## PHASE 2 - WESLEY BRADLEY PARK

EXISTING SITE AND TESC PLAN NORTH  
FOR  
CIVIL PLANS  
PHASE 2 - WESLEY BRADLEY PARK

Job Number  
16718  
Sheet  
C2 of 19

DRAINAGE PLAN SOUTH  
FOR  
**PHASE 2 - WESLEY BRADLEY PARK**

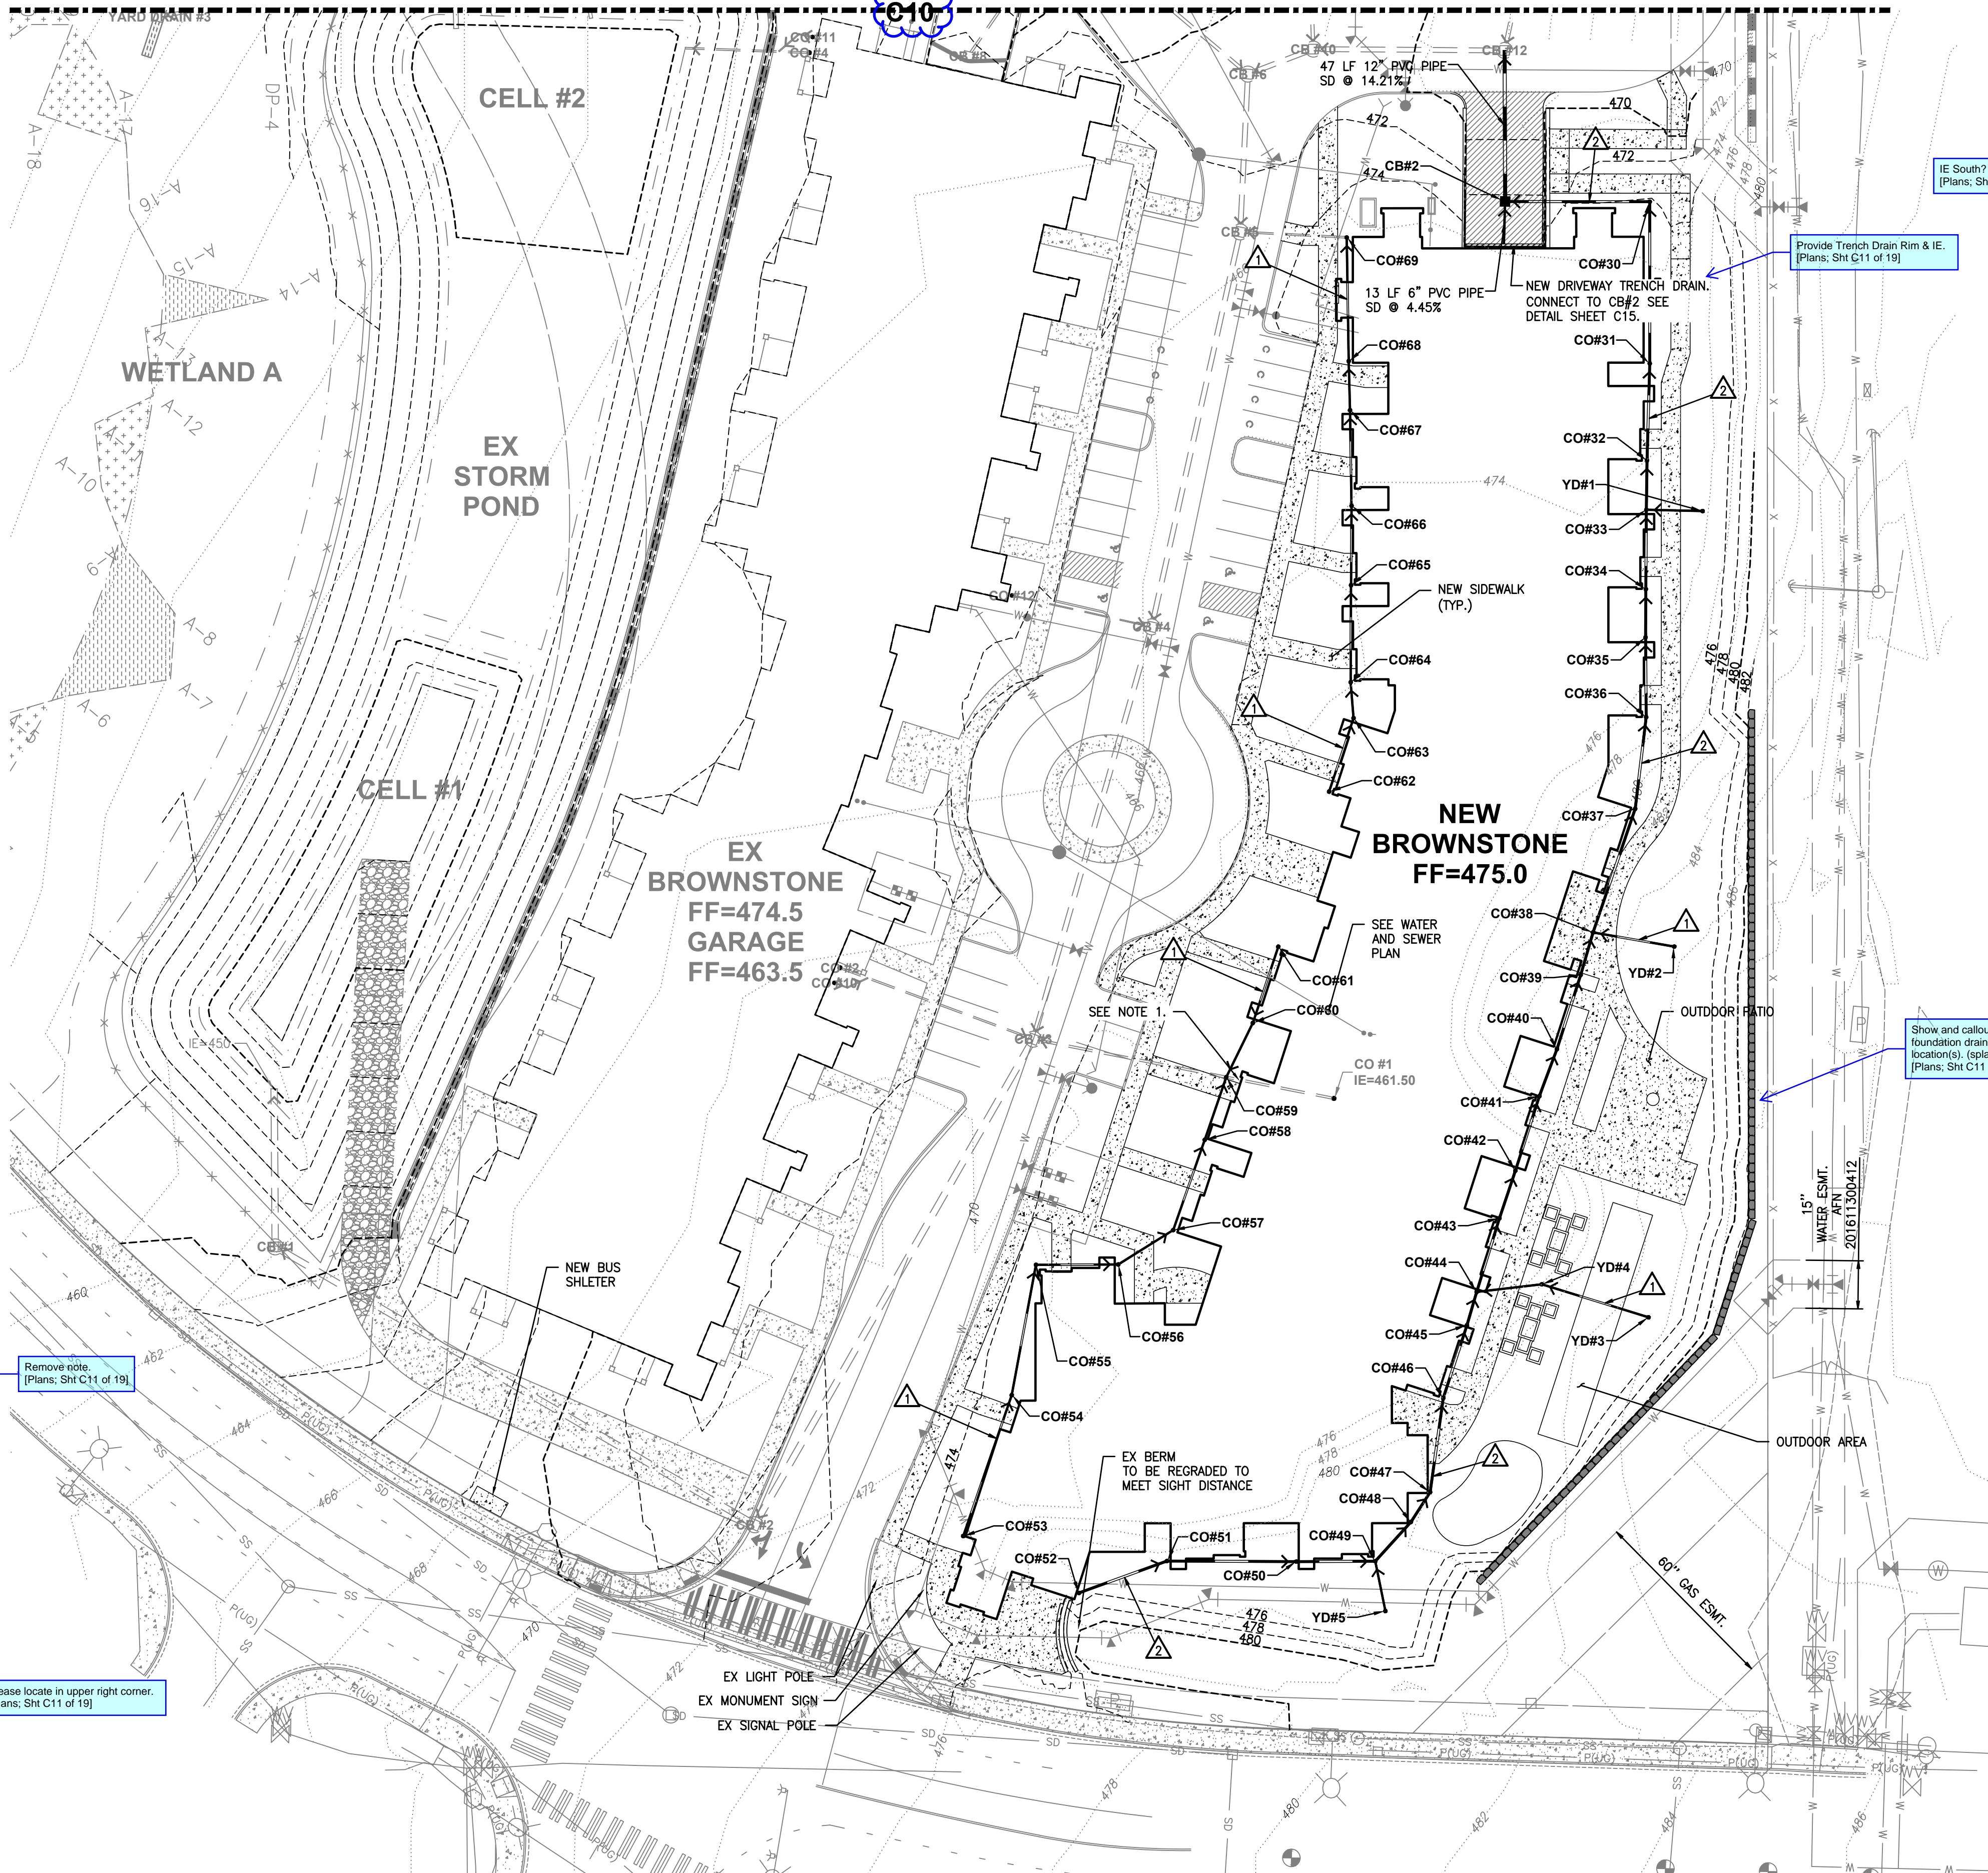
Remove note.  
(Plans: Sht C11 of 19)

IE South?  
(Plans: Sht C11 of 19)

Provide Trench Drain Rim & IE.  
(Plans: Sht C11 of 19)

Show and callout retaining wall  
foundation drain discharge  
location(s). (Splash pad? other?)  
(Plans: Sht C11 of 19)

WATER AND SEWER PLAN NORTH  
FOR  
**PHASE 2 - WESLEY BRADLEY PARK**

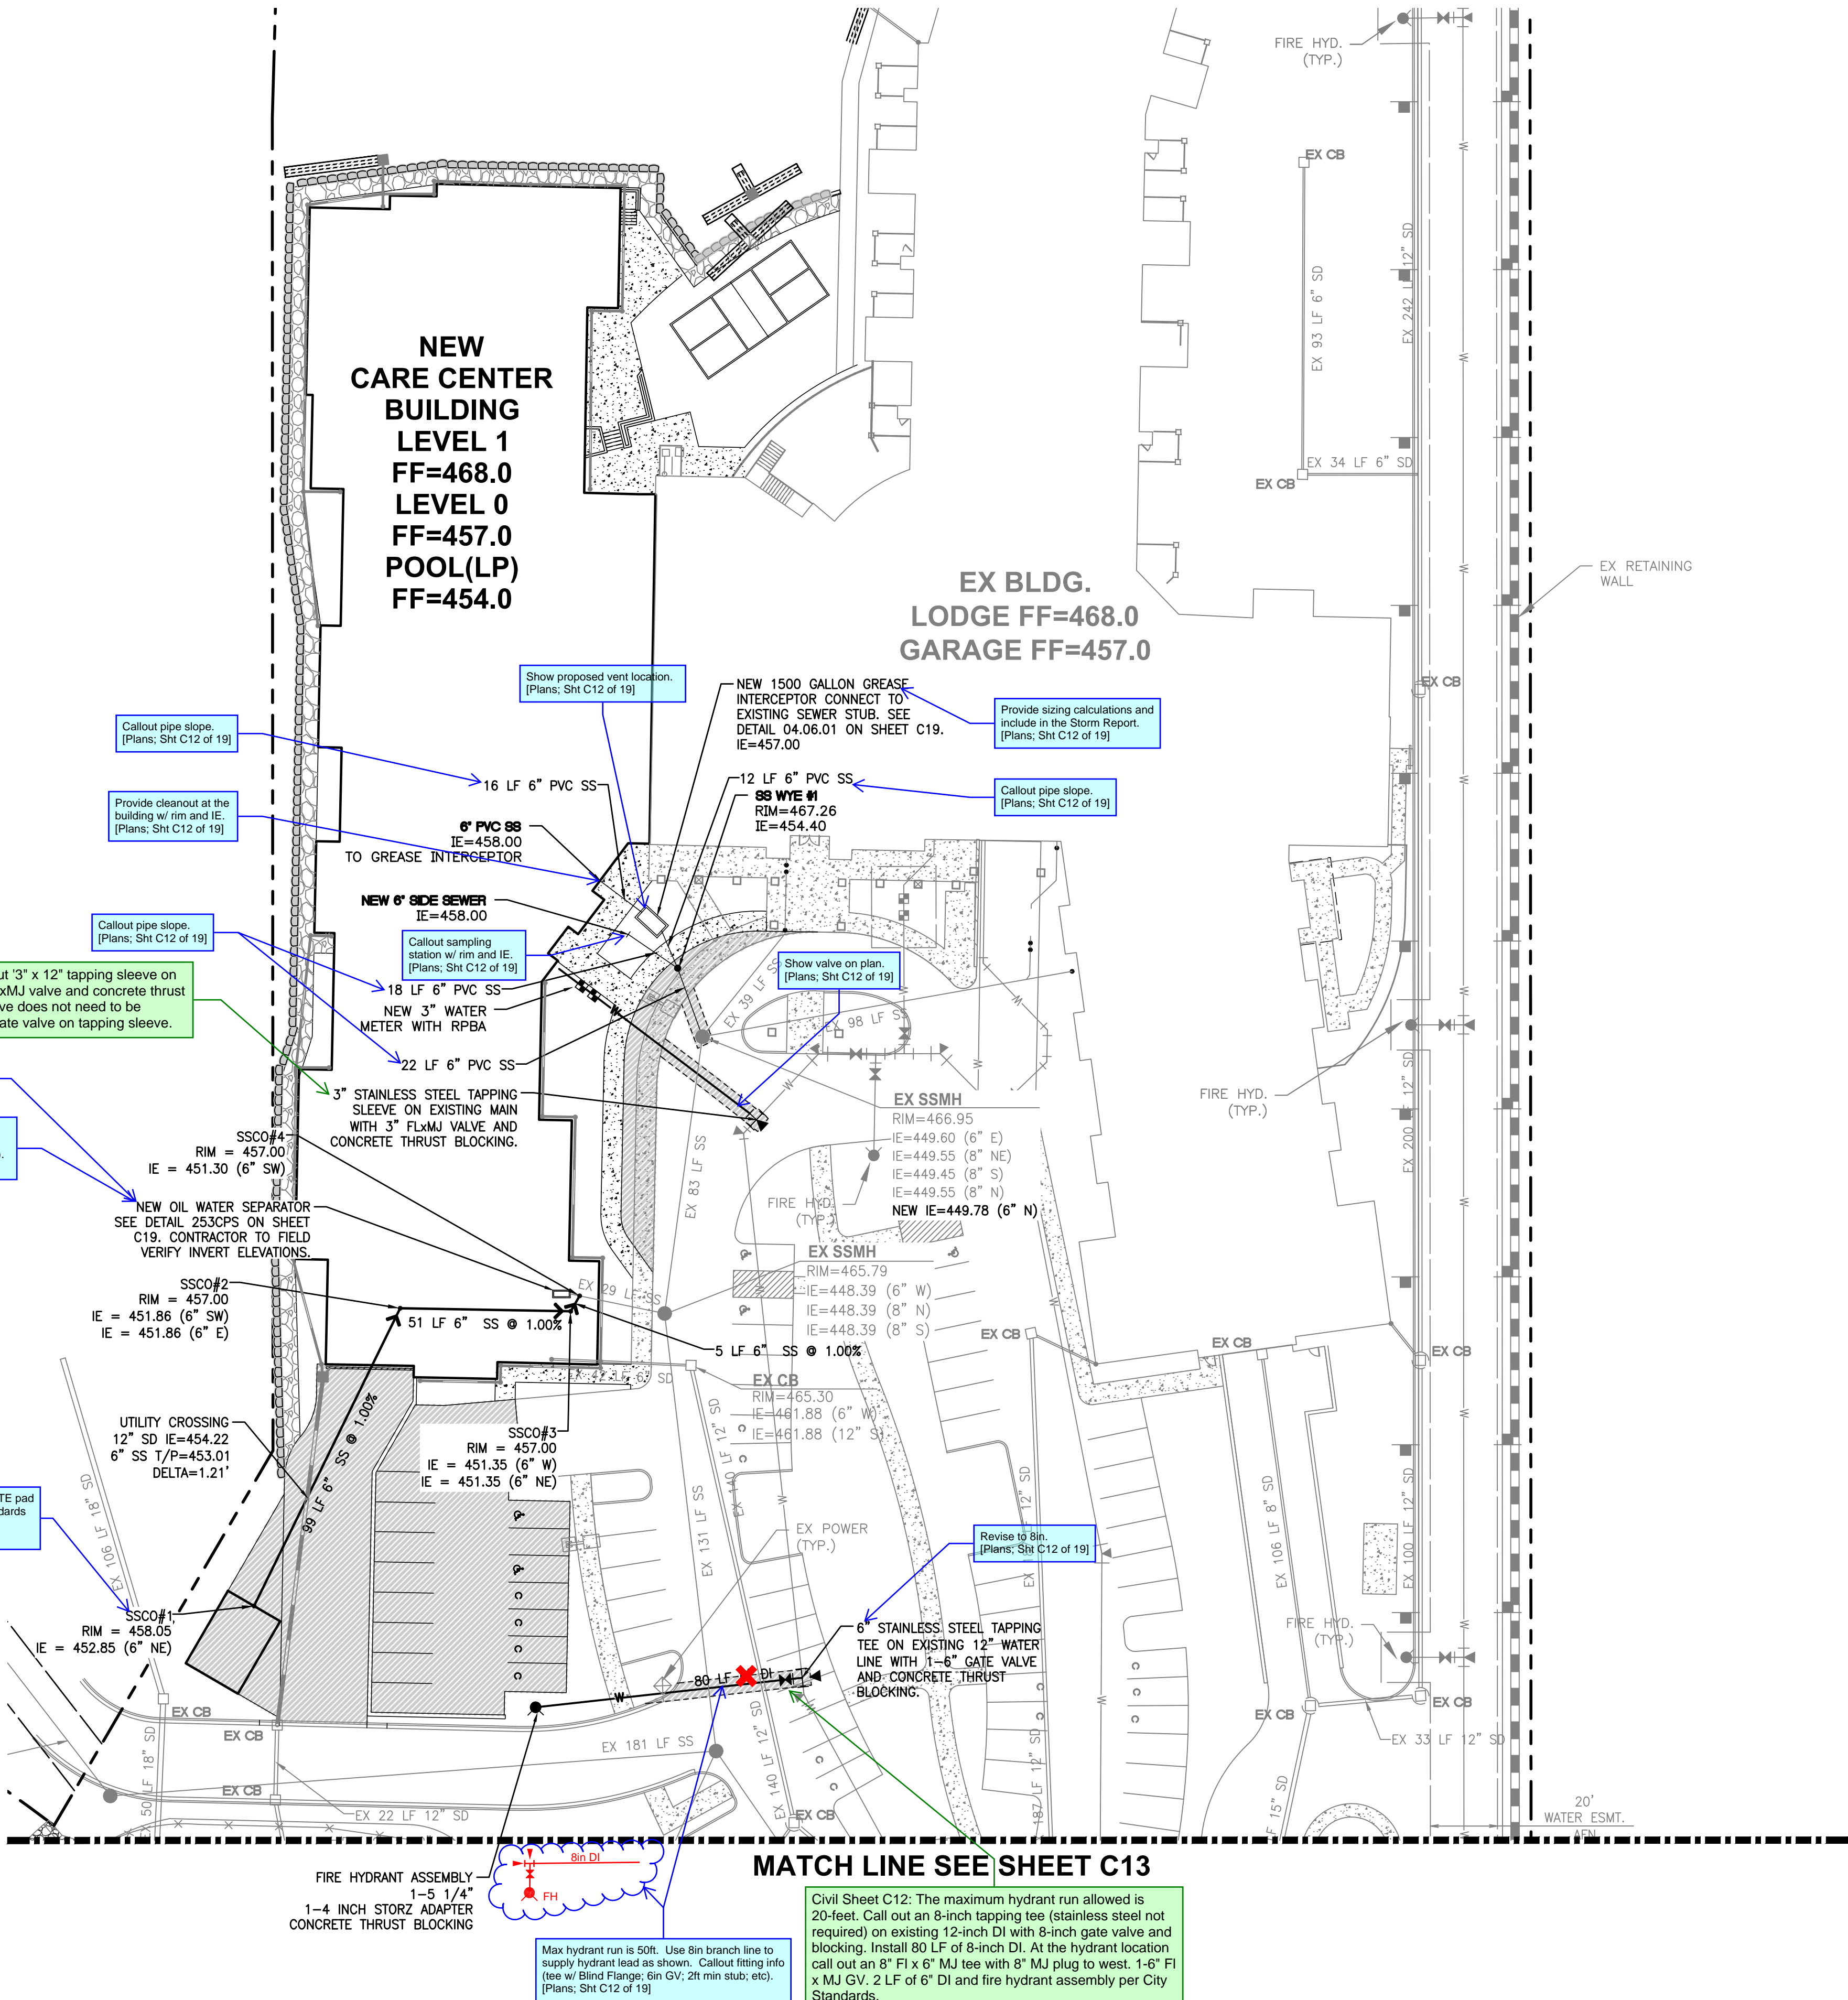
Add Fire Code Official approval block to this sheet.  
[Plans; Sht C13 of 19]

WATER AND SEWER PLAN SOUTH

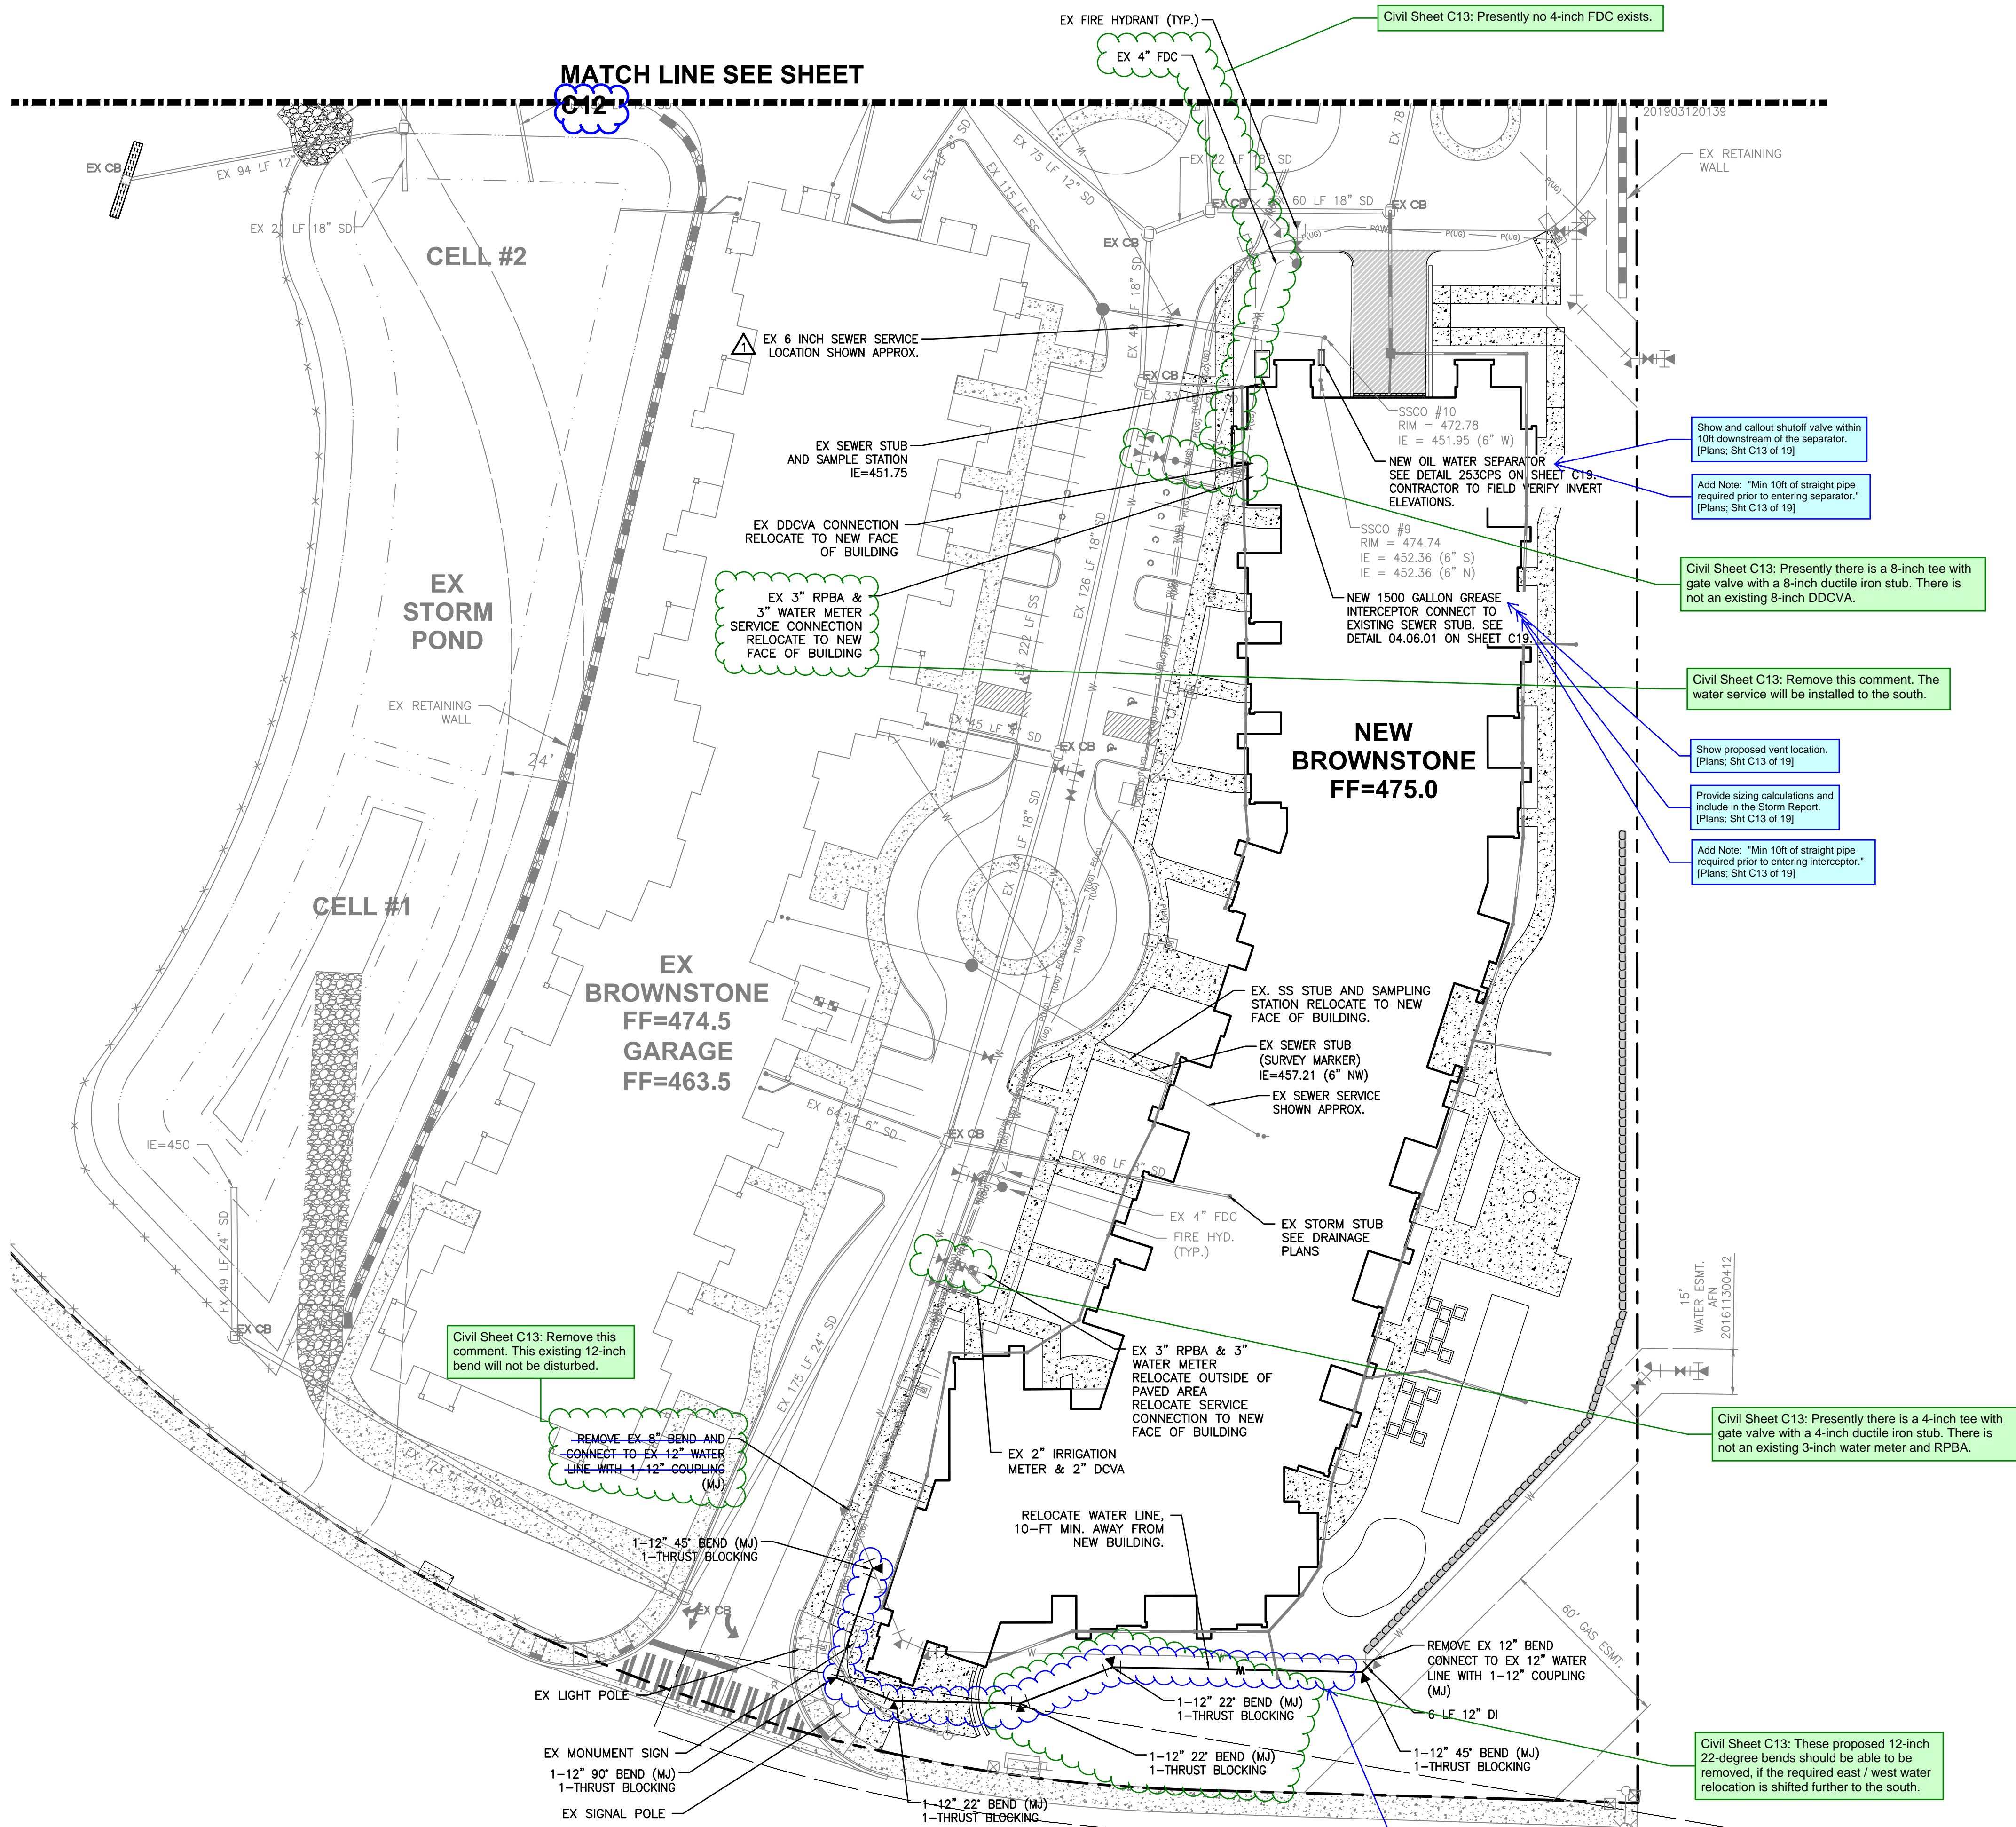
Add Fire Code Official  
approval block to this sheet.  
[Plans; Sht C13 of 19]
